ITEM: 6.1	COMMITTEE OF ADJUSTMENT REPORT SUMMARY MINOR VARIANCE APPLICATION FILE NUMBER A067/23 221 TREELAWN BLVD, KLEINBURG
------------------	---

**COMMITTEE OF ADJUSTMENT REPORT
MINOR VARIANCE APPLICATION
A067/23
221 TREELAWN BLVD, KLEINBURG**

ITEM NUMBER: 6.1	CITY WARD #: 1
APPLICANT:	Marisa Liberta
AGENT:	Bart Szoke Architect Inc.
PROPERTY:	221 Treelawn Blvd, Kleinburg
ZONING DESIGNATION:	See below.
VAUGHAN OFFICIAL PLAN (2010) DESIGNATION:	Vaughan Official Plan 2010 ("VOP 2010"): "Low-Rise Residential" and "Natural Areas"
RELATED DEVELOPMENT APPLICATIONS:	None
PURPOSE OF APPLICATION:	Relief from the Zoning By-law is being requested to permit the construction of a proposed cabana.

Sheet Name
ELEVATIONS

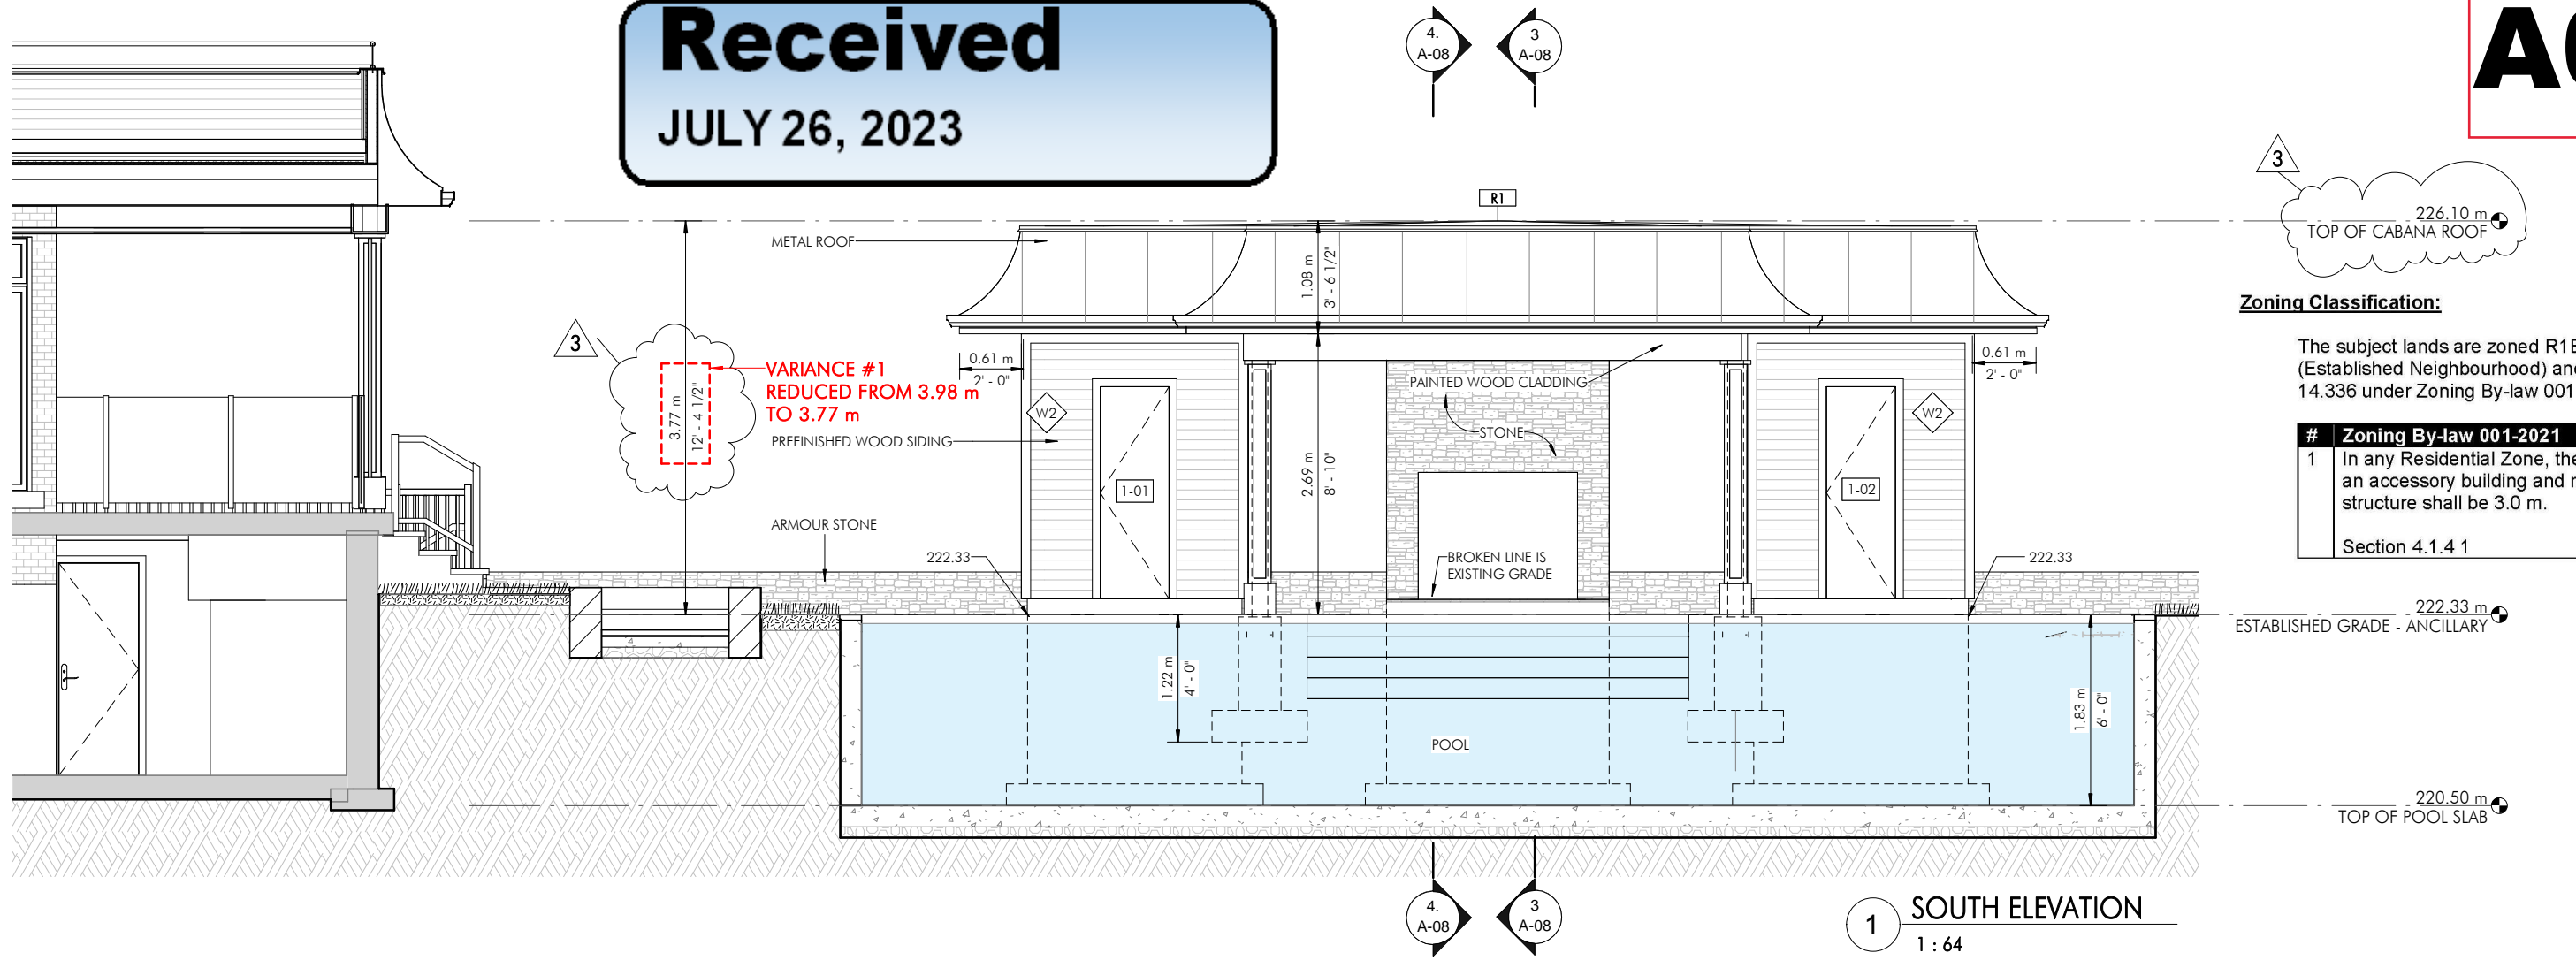
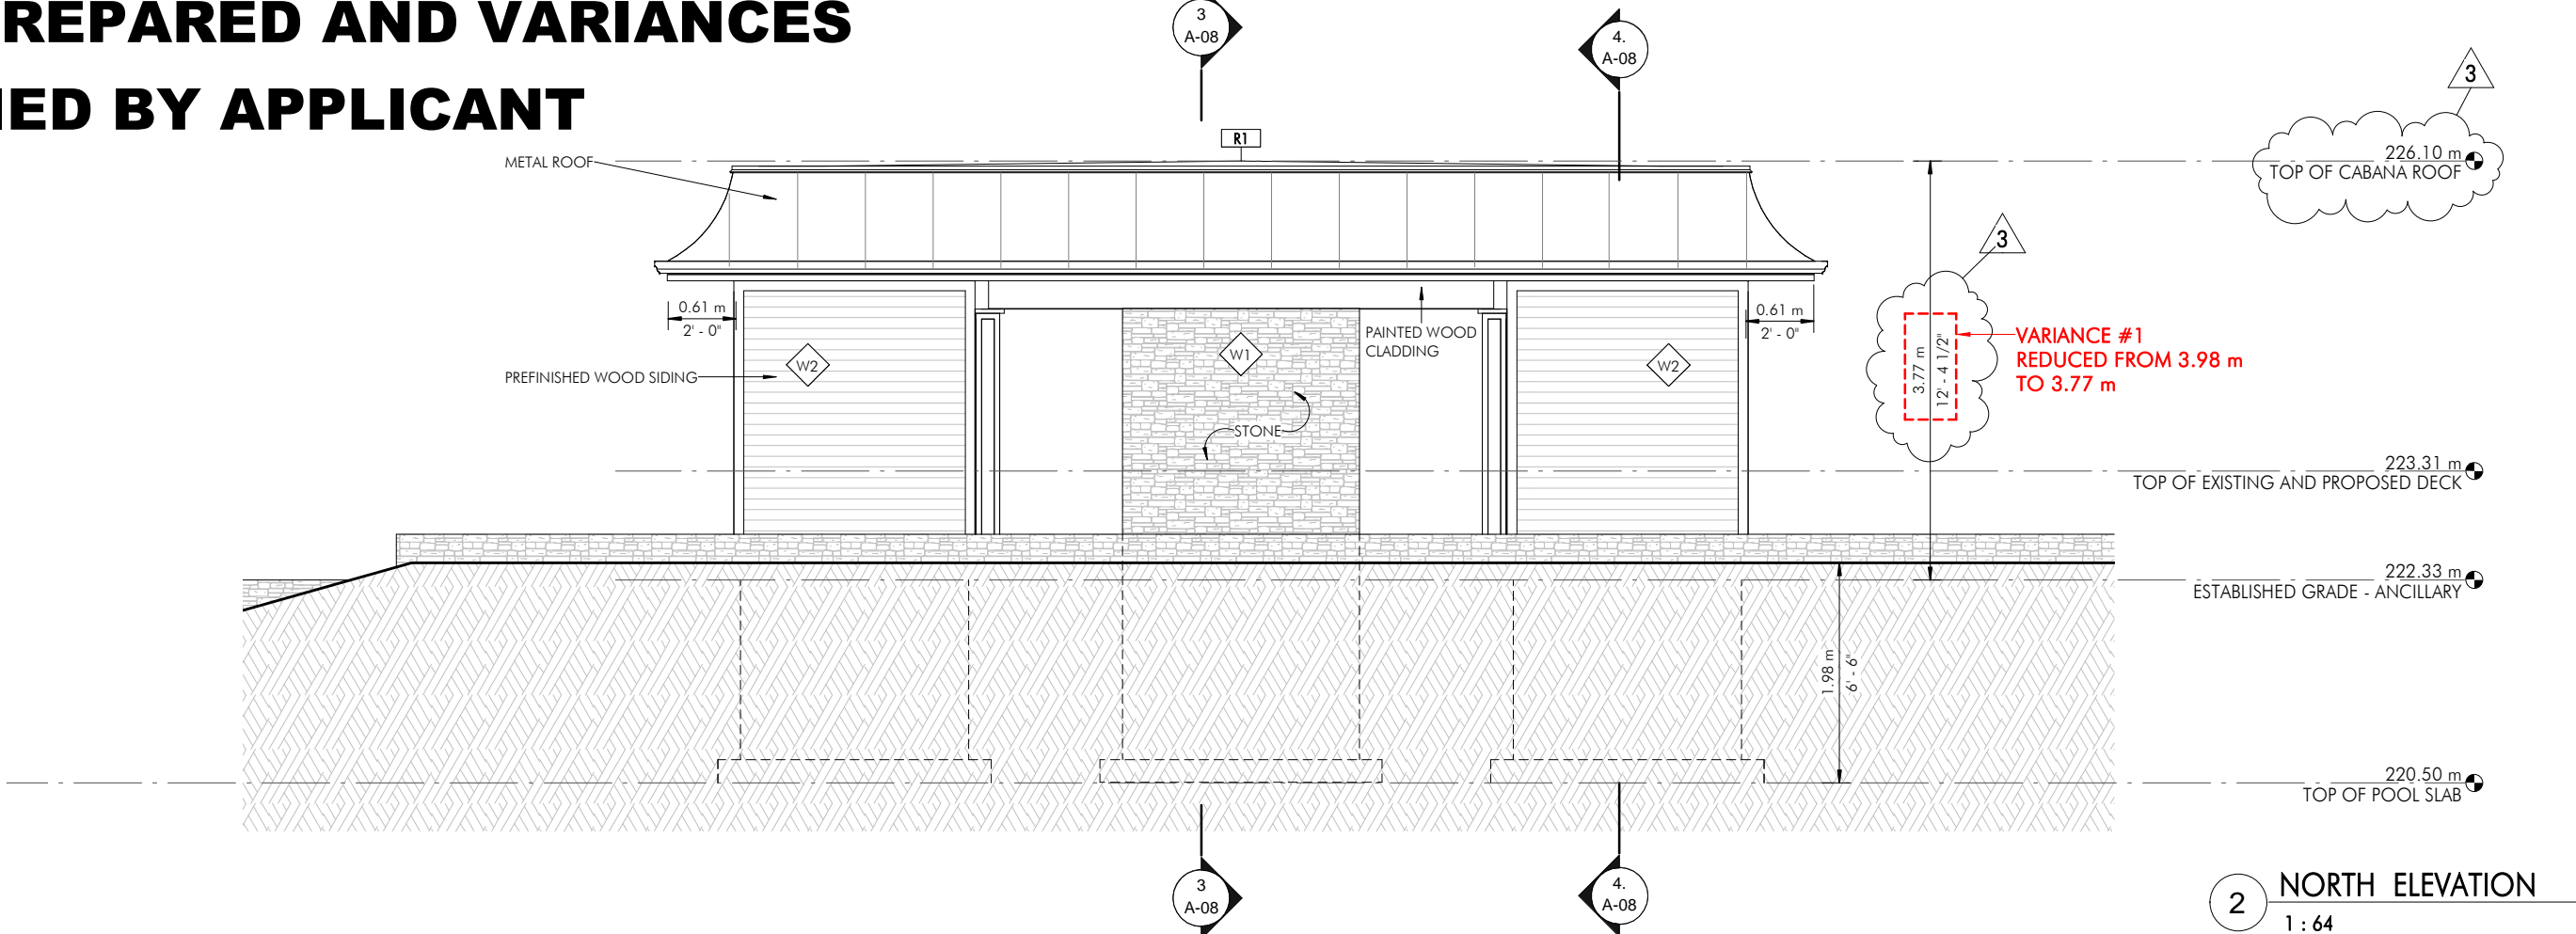
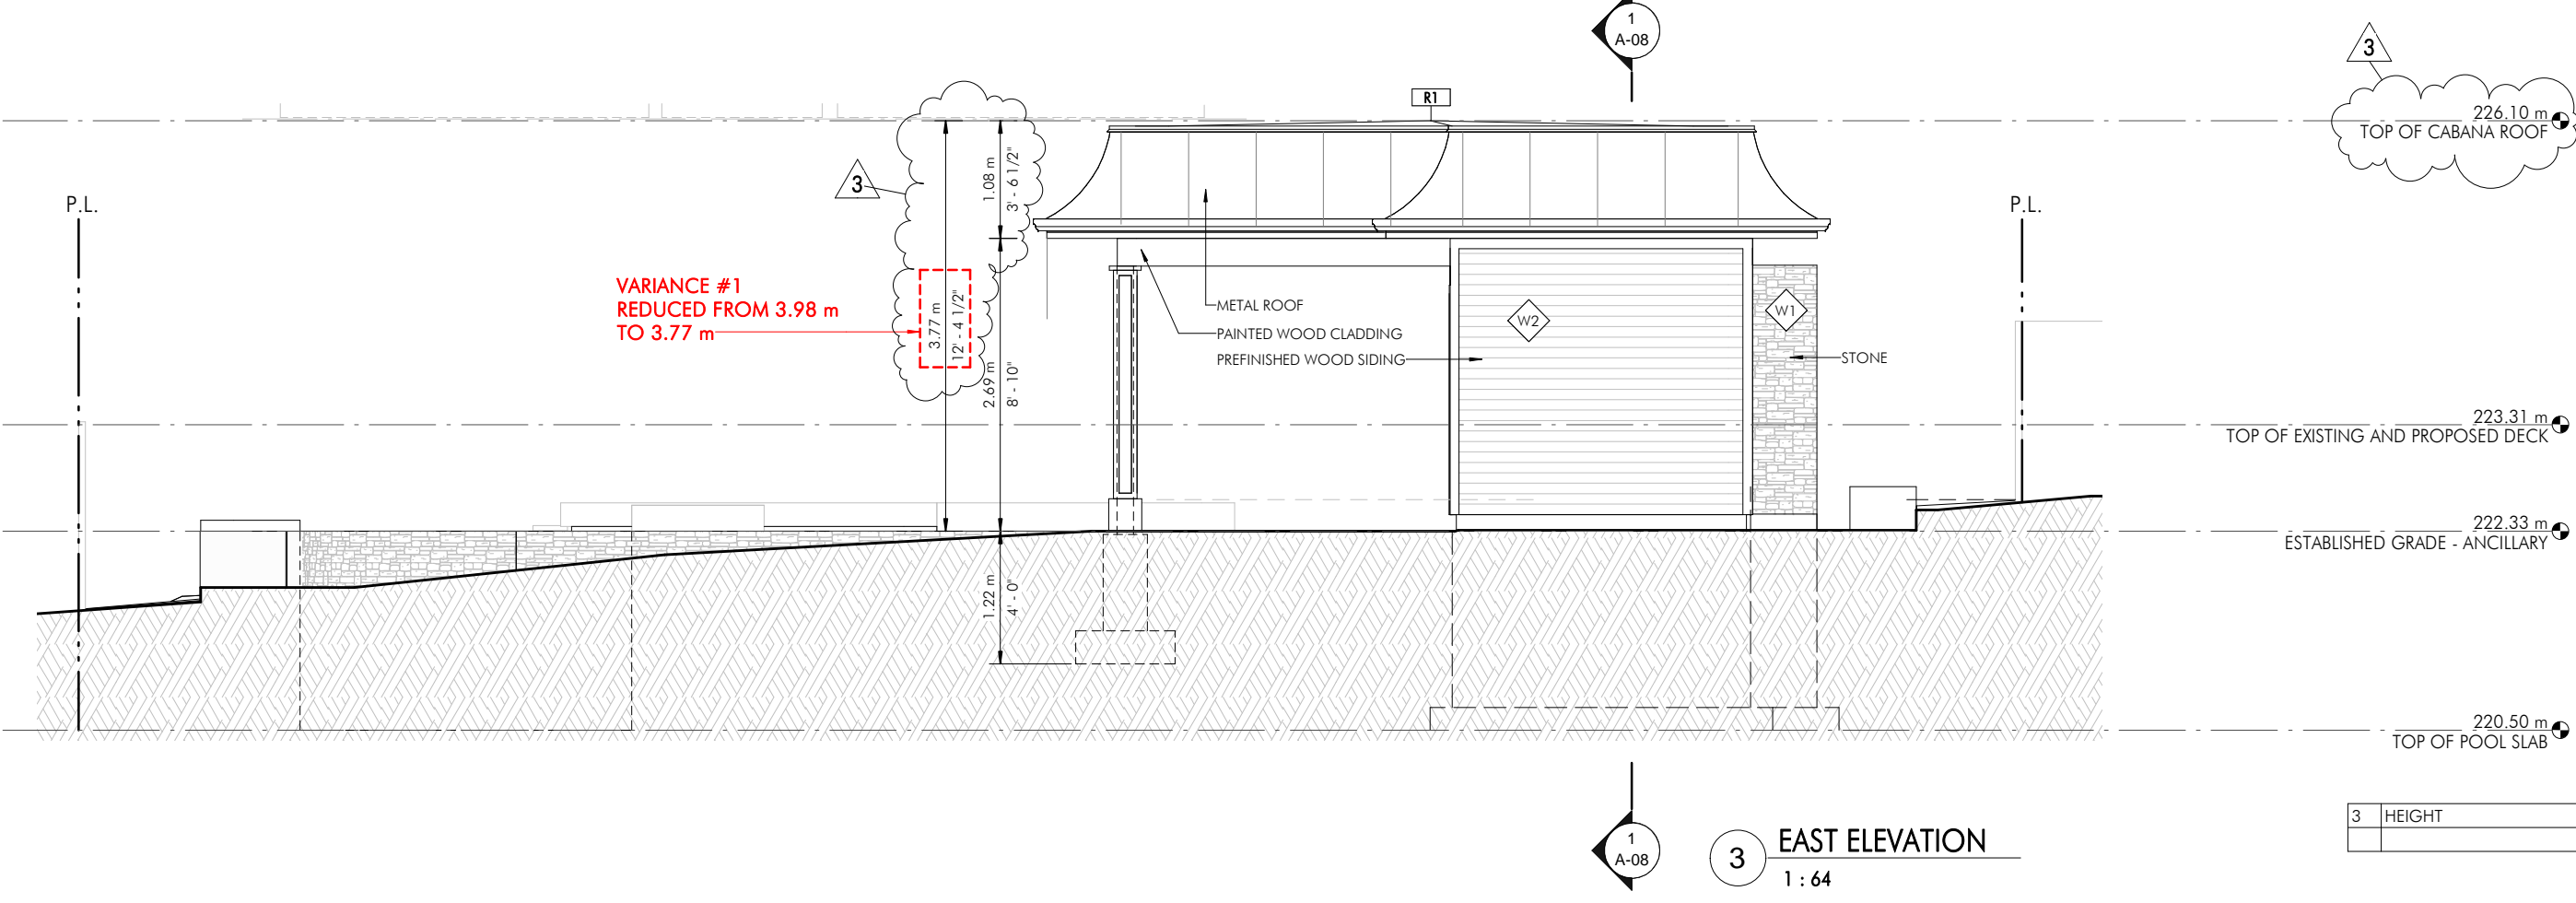
#	Zoning By-law 001-2021	Variance requested
1	In any Residential Zone, the maximum height of an accessory building and residential accessory structure shall be 3.0 m. Section 4.1.4 1	To permit a maximum height of 3.77m for the residential accessory structure.

The Development Planning Department has no objection to Variance 1 to permit a maximum height of 3.77 m for the residential accessory structure. The Owner reduced the height of the structure at the request of Development Planning. The structure is partially open with enclosed rooms on the east and west sides, and a centre wall segment abutting the north interior lot line. The cabana, as a partially open structure, presents less mass overall relative to a fully enclosed structure. The proposed structure meets the minimum interior side yard setback requirements as well as the maximum lot coverage requirements of Zoning By-law 001-2021.
